GOVERNMENT OF THE DISTRICT OF COLUMBIA
DEPARTMENT OF TRANSPORTATION

MEMORANDUM

SUBJECT: BZA Case No. 18915 – 1330-1336 Pennsylvania Avenue SE

Figure 1. Proposed Site Layout (Source: Applicant)

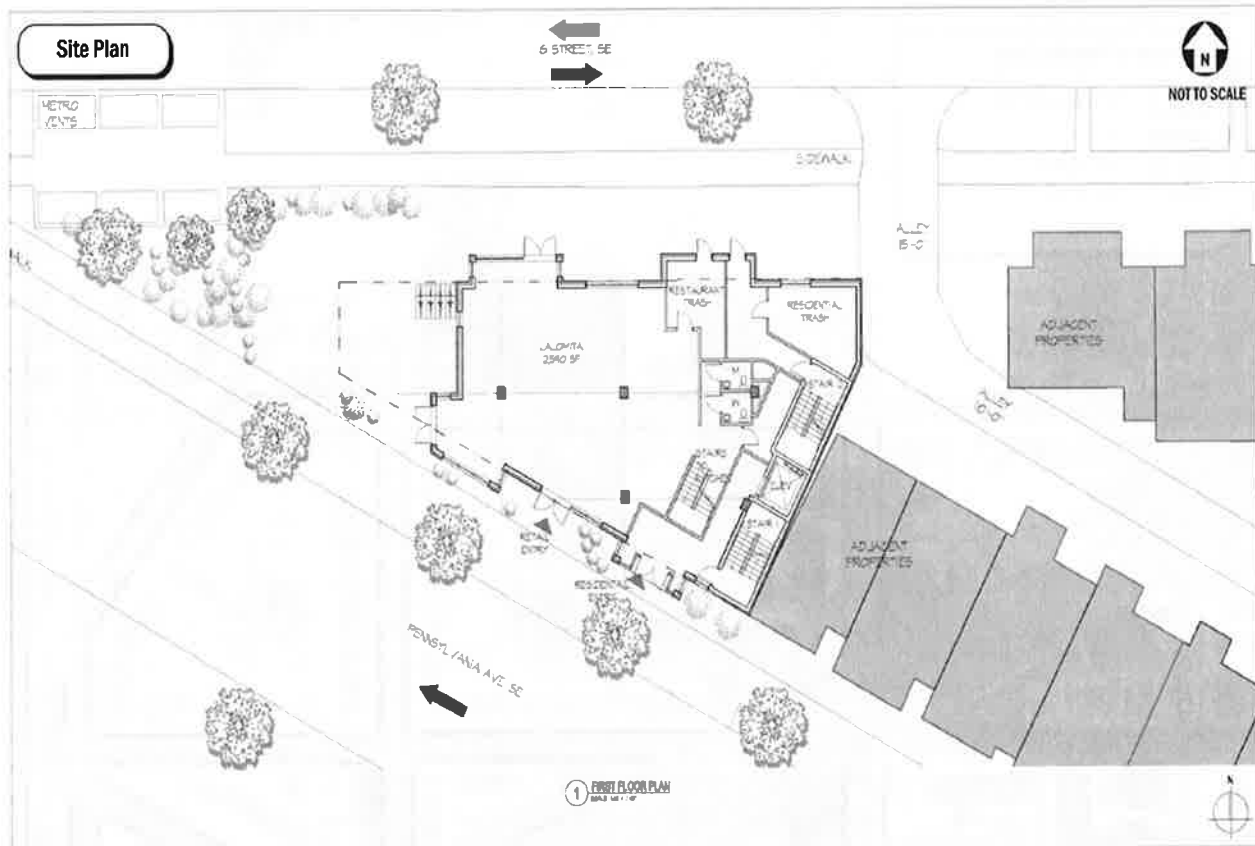
Here, however, the alley adjacent to the Site does not allow through movement due to its narrow width and the building footprint would not allow onsite loading without back-in maneuvers. While not part of this zoning action, a workable loading concept was discussed to show this building can be later permitted as part of the public space permitting process. The Applicant proposes that loading continue to occur from Pennsylvania Avenue via the existing designated loading area in front of the site, which will accommodate most common service/delivery/moving trucks anticipated. Trash pickup will occur from G Street, and will be wheeled from the Site to G Street on pickup days.

This concept is appropriate for the building, considering the Site and alley constraints. A curbside management plan showing the signing at this loading area and around the building, as well as additional loading or trash operational details, may be required. DDOT expects the Applicant to comply with DDOT's standards for loading, the full details of which will be addressed further, as necessary, as part of the permitting process for this property.

Figure 2. Parking Study Area and Parking Type (Source: Applicant)

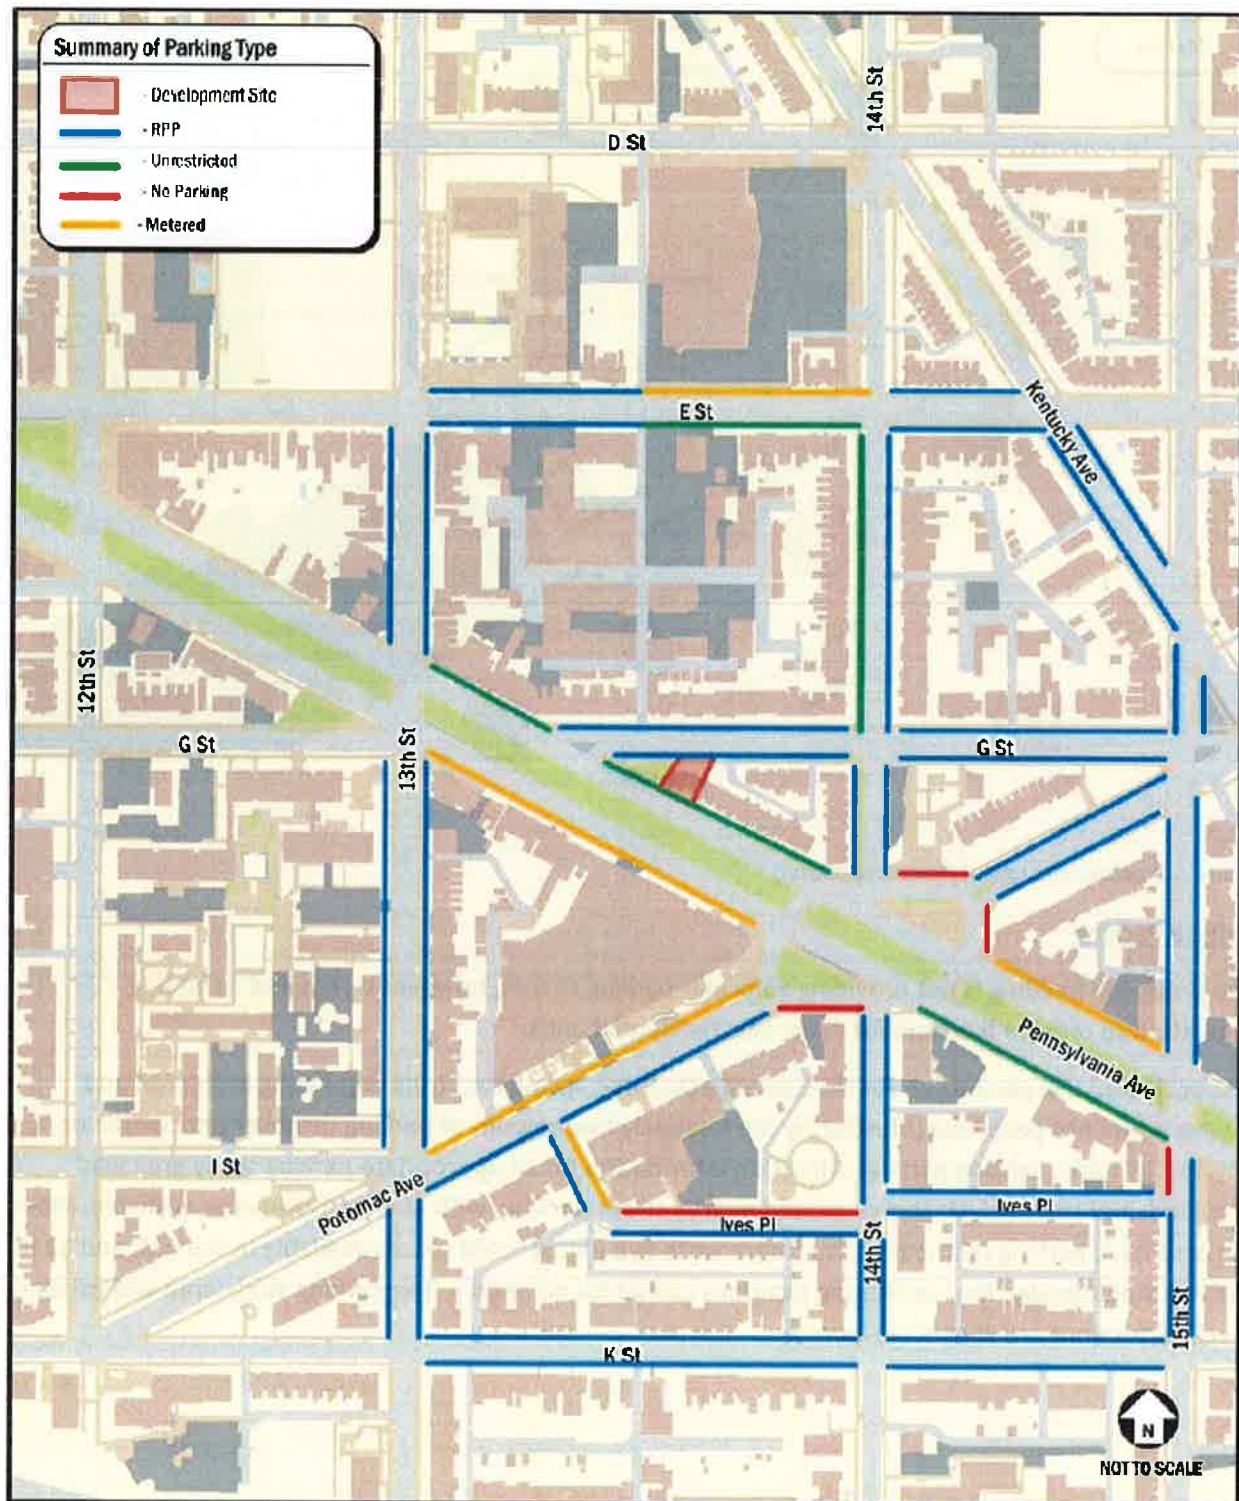
The projected trip generation for the Site expects three auto-based trips originating in the AM and twelve in the PM peak hour, illustrating the relatively low amount of parking turnover anticipated on a day-to-day basis. Existing parking utilization information for an appropriate parking study area was provided, and this analysis shows unused nearby street parking, with at least 128 spaces available. Most of these have parking restrictions, but there were five unrestricted spaces available in the AM, and 12 in the PM. Additionally, four carsharing locations can be found nearby. The parking study area and existing block restrictions are shown in *Figure 2*.

Generally, DDOT has no objection to reduced parking provision if documentation as to where parking could occur is made and if the overall available transportation network supports an appropriate split between vehicular, transit, pedestrian, and bicycle trips. Thus, DDOT finds appropriate the lack of parking provision in this area due to the close proximity to transit, provided bicycle storage, nearby
